REMARKS

This is in response to the Office action mailed July 25, 2005.

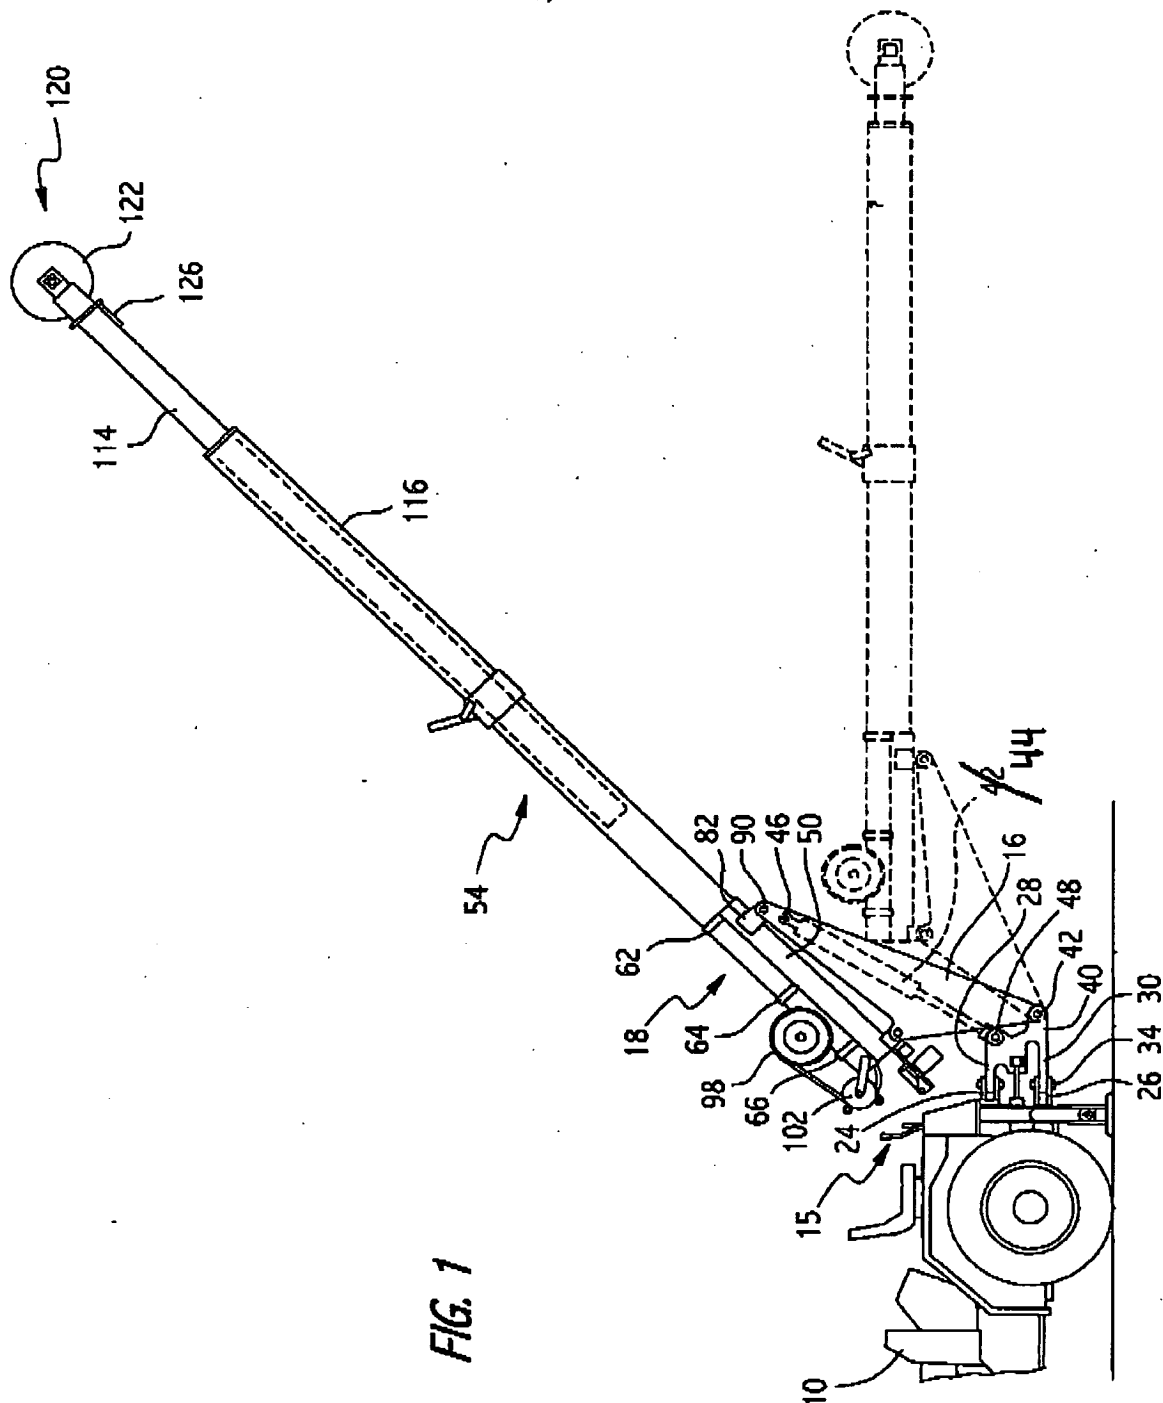
The drawings are objected to for failing to comply with 37 C.F.R. 1.84(p)(4) because character "42" has been used to designate both a pivot pin and a cylinder in Figure 1 and 37 C.F.R. 1.84(p)(5) because the drawings do not include the reference signs 11, 13, 86, 95 and 97, which are mentioned in the description. Applicant is submitting herewith a drawing page showing changes to Figure 1 wherein character "42" referencing a cylinder

has been changed to character "44" and to Figures 3 and 6 wherein a character "84" referencing a tube has been change to character "86." Replacements sheets reflecting these amendments are also submitted herewith. In addition, applicant has amended the specification to remove all references to characters 11, 13, 95 and 97. Accordingly, withdrawal of the objection is respectfully requested.
